Comments on Covariance Data of JENDL-4.0 and ENDF/B-VII.1

April 22, 2014

M. Ishikawa, JAEA

Pu-239 Fission (1/3)

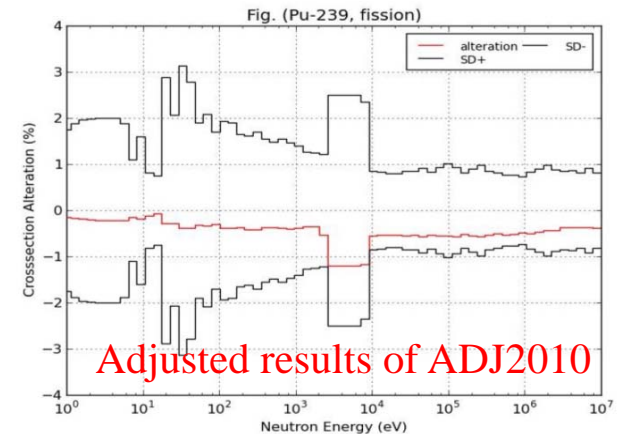
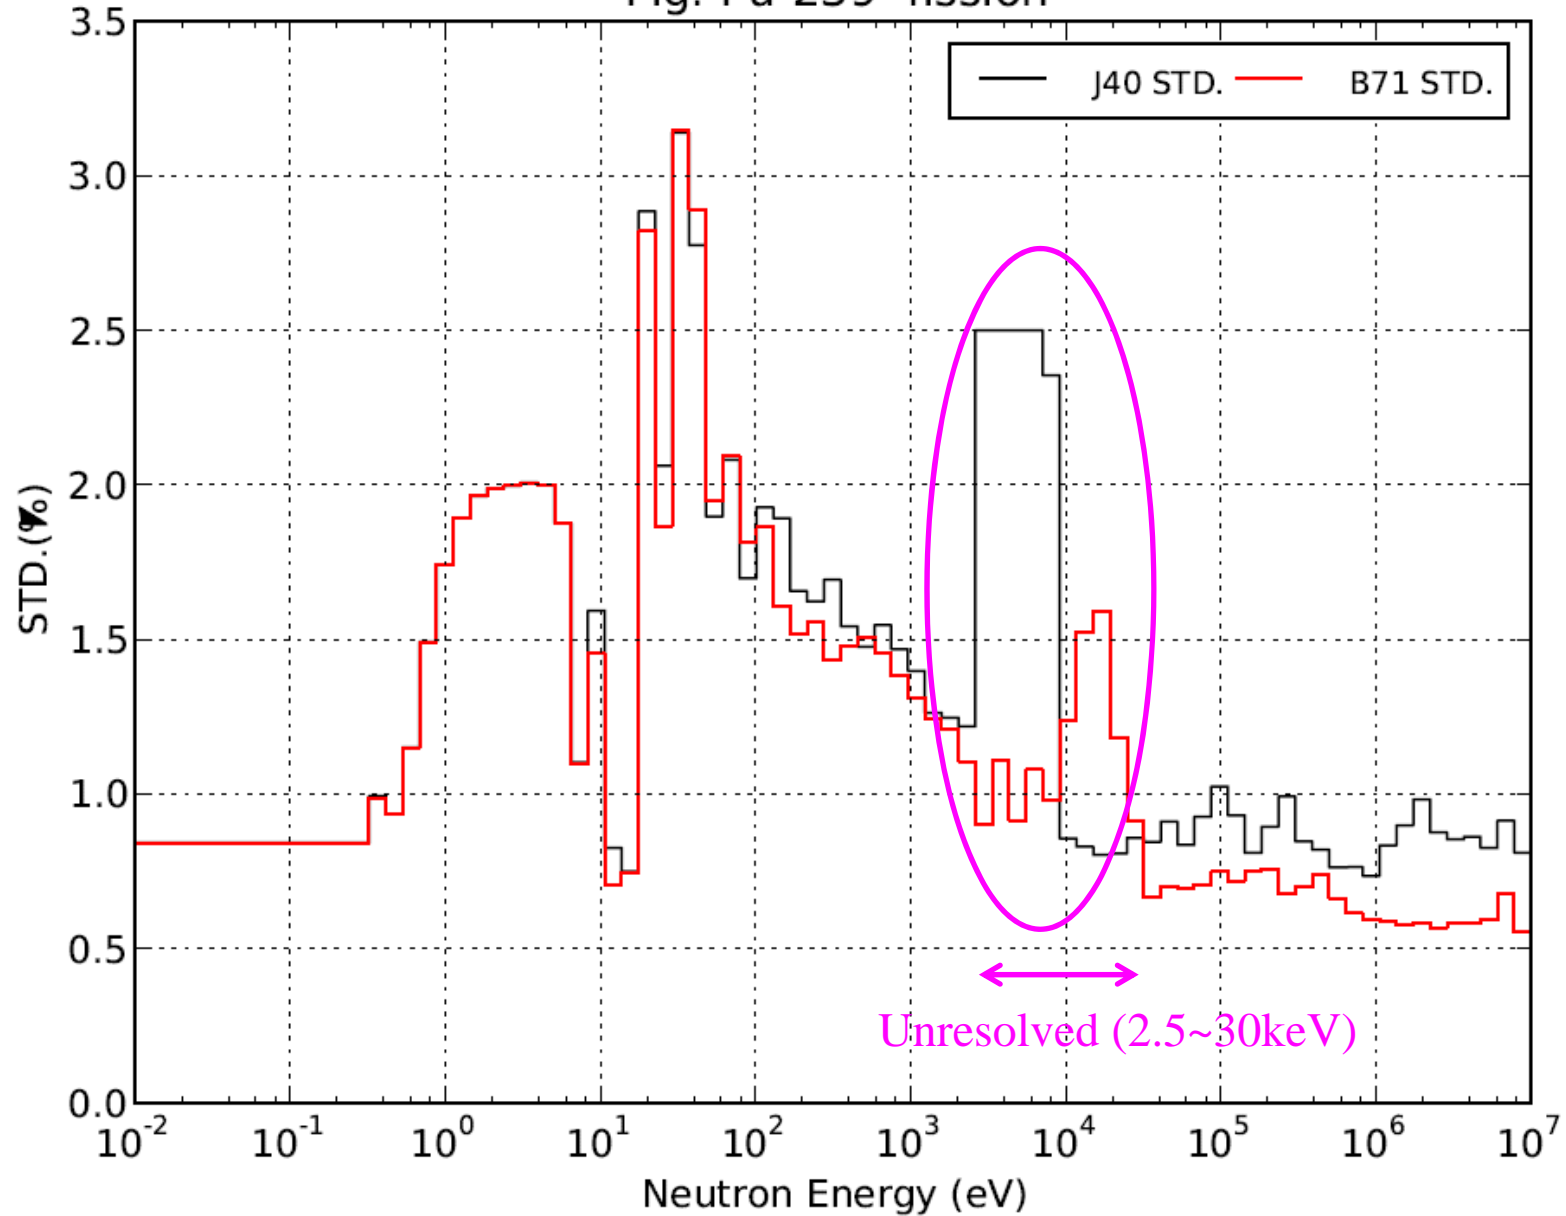
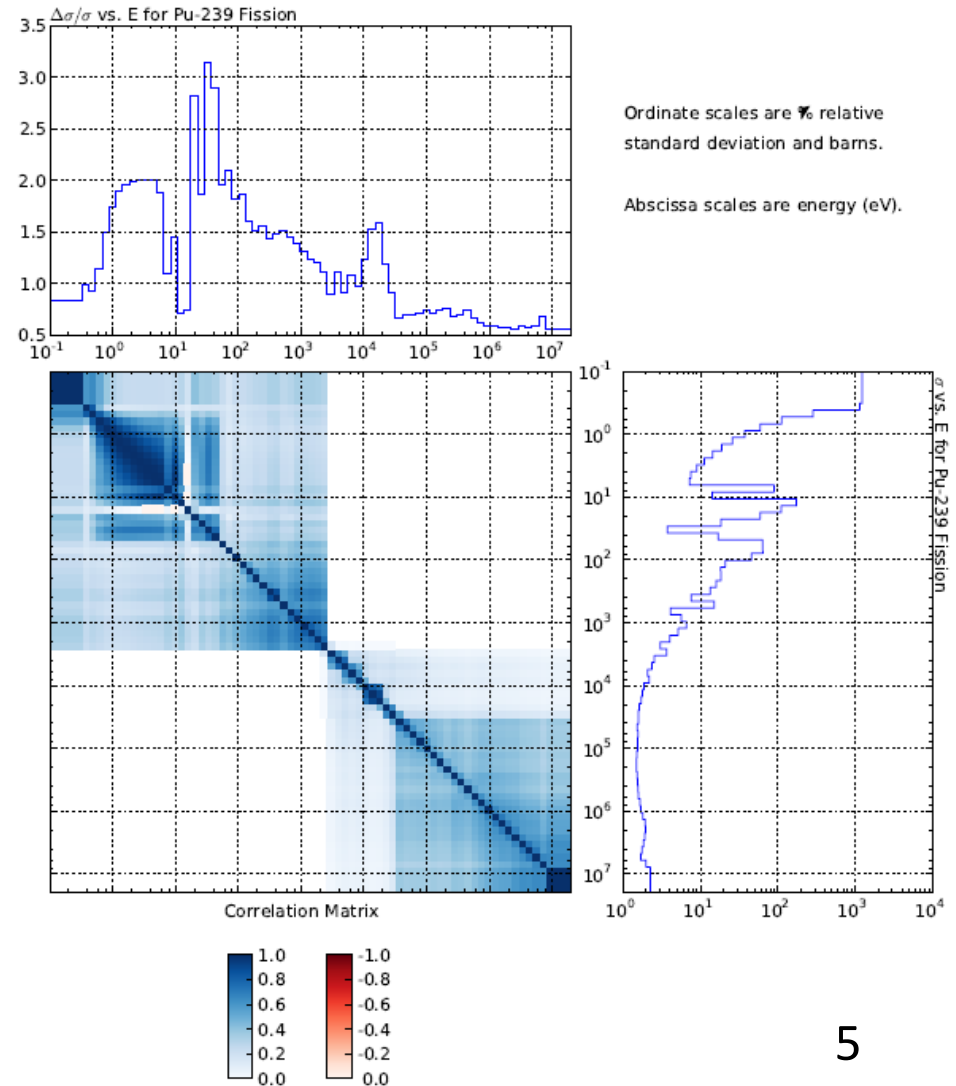
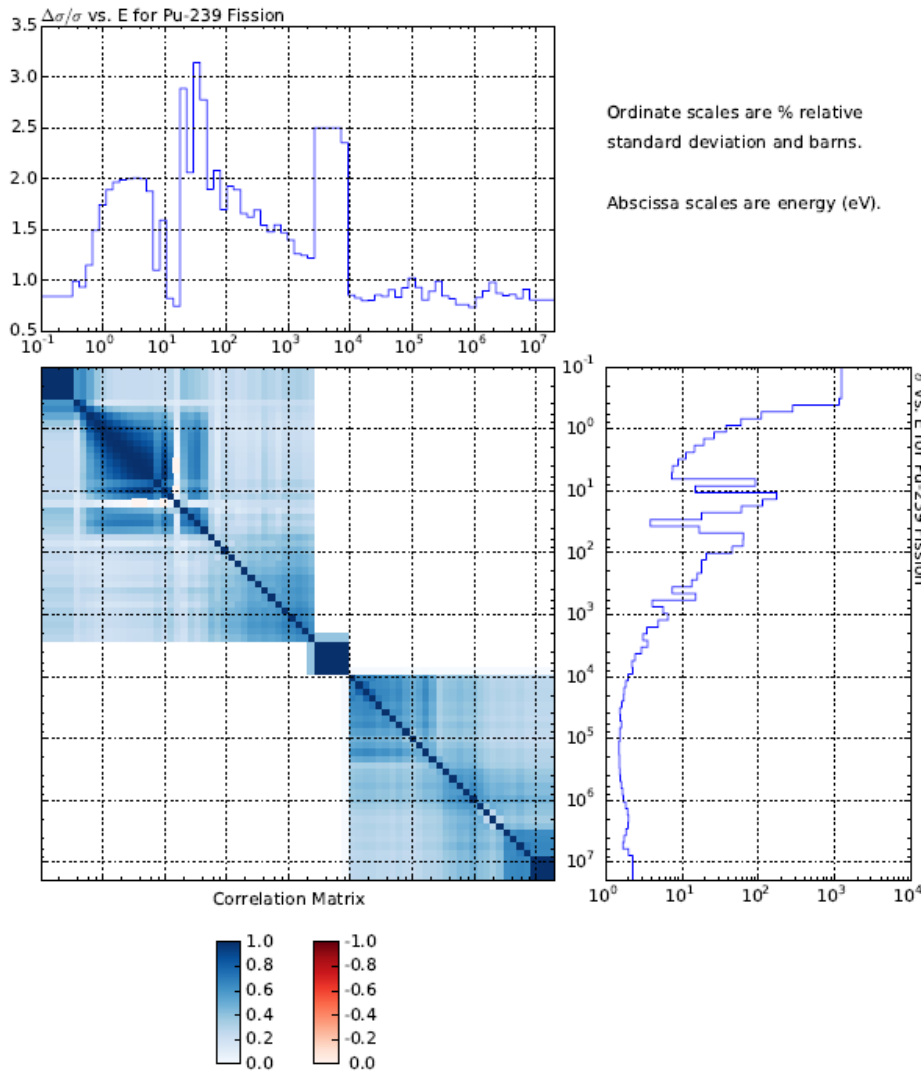
In **JENDL-4.0**, the standard deviation (STD) of **2.5~10keV** is **significantly large** in the unresolved resonance region of 2.5~30keV. No such discontinuity is seen in ENDF-7.1.

In the former JENDL-3.3, the covariance of the whole unresolved resonance region was evaluated from the uncertainty of resonance parameters, therefore, the STD was generally large. Above 10keV, JENDL-4.0 changed to adopt the simultaneous evaluation for major fission isotopes for the center values of fission cross-section, and the resonance parameters were only used to calculate the shielding factors. Since the simultaneous evaluation was found to evaluate the STD too small, the variance of JENDL-4.0 was multiplied by a factor of 2^(J-2, p.1226), but still small compared with the STD of JENDL-3.3, which was carried over to JENDL4.0 in 2.5~10keV^(J-6). Since the evaluation method of the covariance is consistent with that of the central value of cross-section, the discontinuity at 2.5~10keV is physically acceptable. However, the cross-section change by adjustment followed this covariance discontinuity as the figure above.

It is **desirable** for **JENDL-4.0** to **improve** the evaluation of **2.5~10keV region** soon.

Pu-239 Capture (1/3)

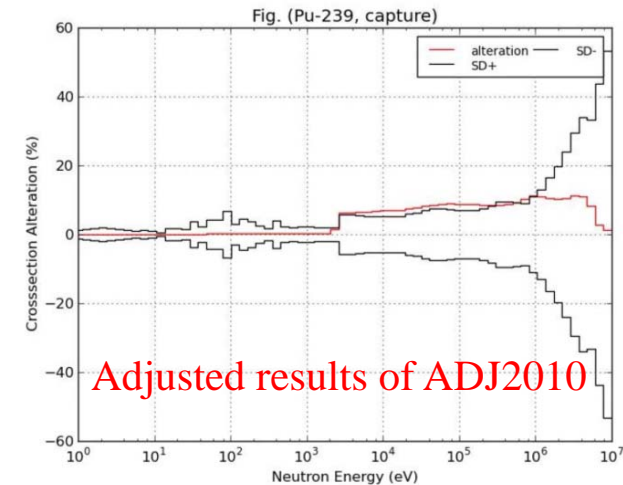
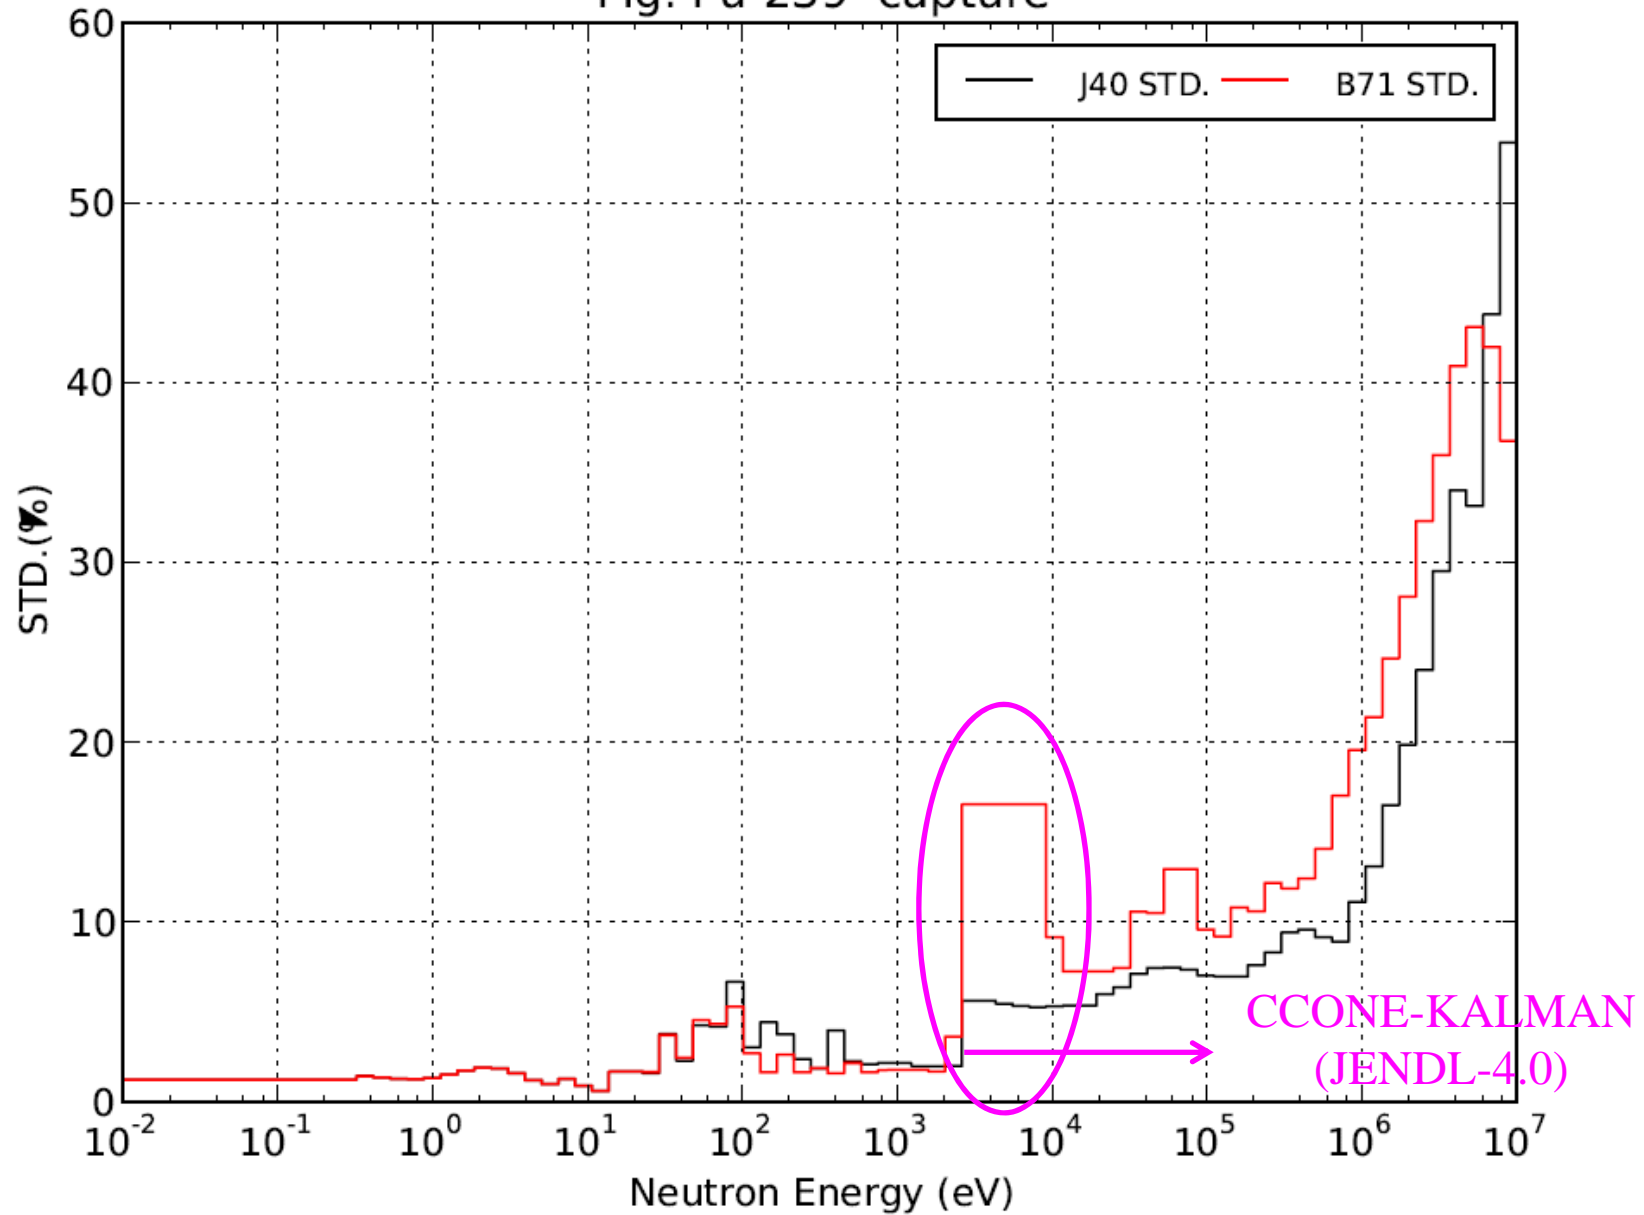
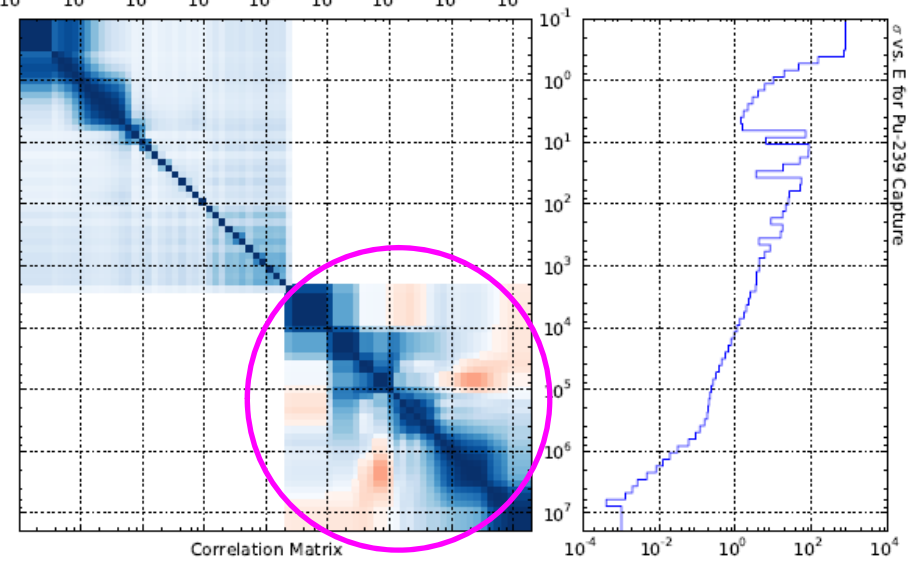
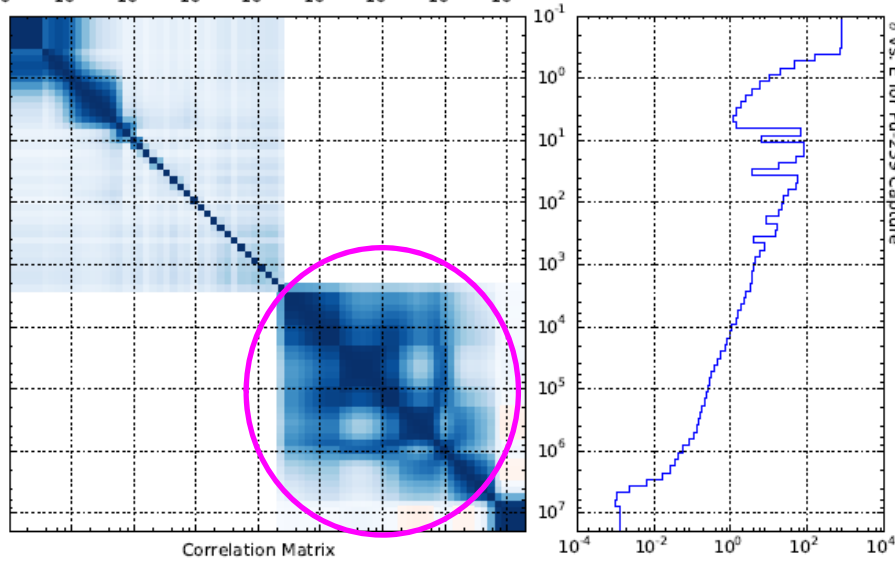
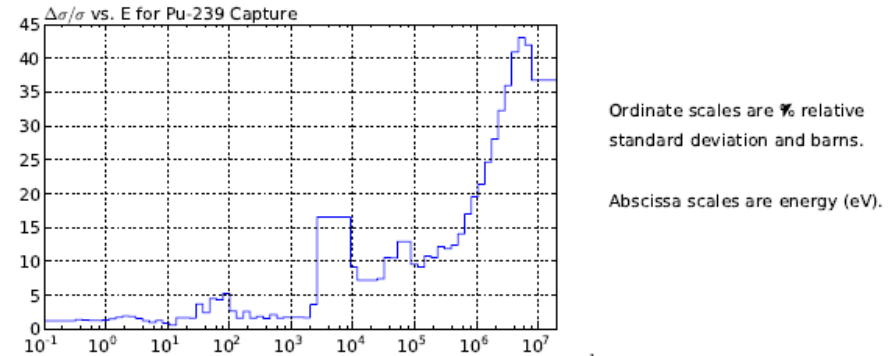
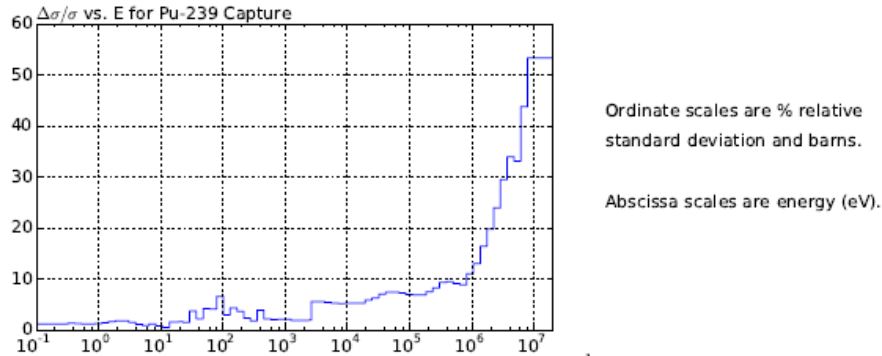
The **STD of ENDF-7.1 is notably large in 2.5~10keV**, on the other hand, that of JENDL-4.0 is quite smooth above 2.5keV.

Above 2.5keV, JENDL-4.0 adopted the results of the CCONE-KALMAN, not the simultaneous evaluation, therefore, the STD tends to be smooth in the high energy region^(J-6). However, there seems no explanation in the ENDF-7.1 comment file^(E-3) to correspond to this discontinuity. In the US, there seems an opinion that the Pu-239 capture cross-section above 2.5keV should be 10% larger than ENDF-7.1^(E-5), but no information on the relation with this covariance trend. Only for information, the adjusted result of ADJ2010 is shown in the figure above.

SG39 may **ask the ENDF evaluators** if there is **any physical reason** for this **discontinuity**.
